Commentary / objection to proposal 2013/5689/P

The site, 152 Royal College Street, is located within Camden Broadway Conservation Area. The map below shows the boundaries of the conservation area, and highlights the adjacent building (no 154) as a 'positive building'.

Proposal - Design and Access Statement

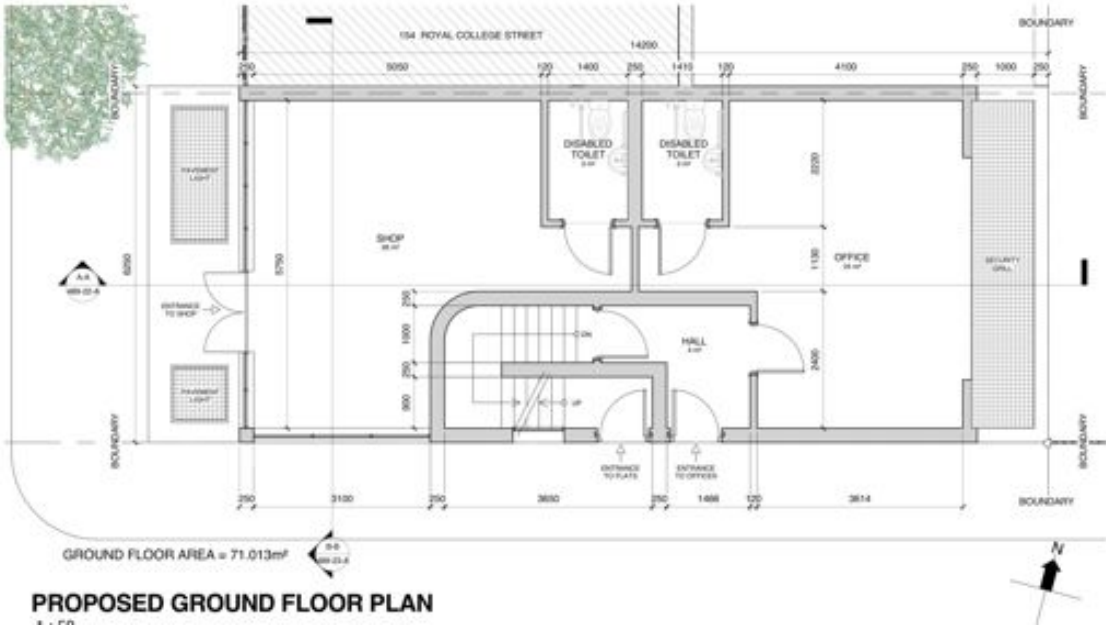
The elevational treatment focuses the front of the building on Royal Colege Street, whilst the ground floor plan locates the building's main entrances (residential and office) on Baynes Street. This unclarity is amplified by the side elevation's lack to address the site's corner location and its failing to address the prominent view from canal entrance.

Instead of 'turning the corner', the building only addresses Royal College Street with a front, and treats Baynes Street like an insignificant side regardless of the two entrances located there. The residential entrance (the building's main access point for all residents) isn't designed as such, and looks both in plan and elevation like a secondary entrance. Further to that, it lacks an entrance hall such as the one provided for the adjacent office entrance. This raises questions such as the location of mailboxes and residential waste storage.

The proposal should address both streets in a clear, coherent way, providing the office and residential entrances with the status and architectural expression worthy of a building's main access point. Equally, the design of the Baynes street facade needs to be coherent and in keeping with the features of the Royal College Street facade. Whilst the Design and Access Statement claims *"But for reasons of space provision it is not practical to set back the side elevations at this level. This is a very narrow corner site. Further cut backs in the floor space for the residential floors will seriously negate the amenity currently afforded."*, the currently proposed 1-bedroom apartment is with 60sqm rather large, and a more refined designed response will find ways of both integrating a setback (however small) in the massing of the building and providing a suitable apartment on the 3rd floor. If this is not possible, then the suitability of the fourth storey or the unit mix ought to be questioned, rather than compromising the massing and appearance of the proposed building.

This statement is in conflict with the Camden Broadway Conservation Area Management Strategy: *"It is clear from the conservation area appraisal that a key element of the distinctive character and appearance of the Camden Broadway Conservation Area is the area's broadly consistent architectural style, scale, form and materials."*

The Conservation Area Appraisal identifies the area's architectural unity as a positive characteristic, rather than 'aggressive', 'dominating' and in need of 'contrasting' or 'softening' as described in the proposal's Design and Access Statement. Rather than standing out by contrasting the adjacent

buildings (as proposed), any building on this site should enhance the coherence of the street by using solid brick materials. Brick can be used in a variety of ways, and can easily provide a suitable 'corner location appearance' without detracting from the street as a whole.

The balconies are at the most 100cm, at the least 65cm deep. The floor plans indicate a small plant pot as their only use, as they are too narrow to accommodate any type of seating or other outdoor use furniture.

It seems that in order to make a fourth floor viable, the proposal has compromised the outdoor space provision to the extent that the balconies are rendered near unusable. The proposal needs to provide high-quality homes, and it seems that the ambition of 2x 2-bed and 1x 1-bed apartments is too much for this site. An arrangement of 1x 2-bed (first floor) and 1x duplex 3 or 4-bed (second and third floors) apartments would allow for better quality homes, and (as per 1.) improved massing and appearance.

The Design and Access Statement needs to provide further detail to prove its compliance with the Conservation Area Management Strategy. No mention is currently made of the quality of facade materials, the treatment of features such as the balconies, the detailing of the shopfront (given its adjacency to the 'historic shopfront' of no 154 etc.

Vague reference can be found in the Sustainable Design Statement to a Green Wall, but no further detail can be found on any of the plans, sections or views, even though a Green Wall would be a major feature (including its maintenance requirements).

It is not clear from the ground plan where this opportunity could be, given the already minimal entrance arrangement for the residential floors. Further detail is required to ensure DDA and Lifetime Homes compliance.
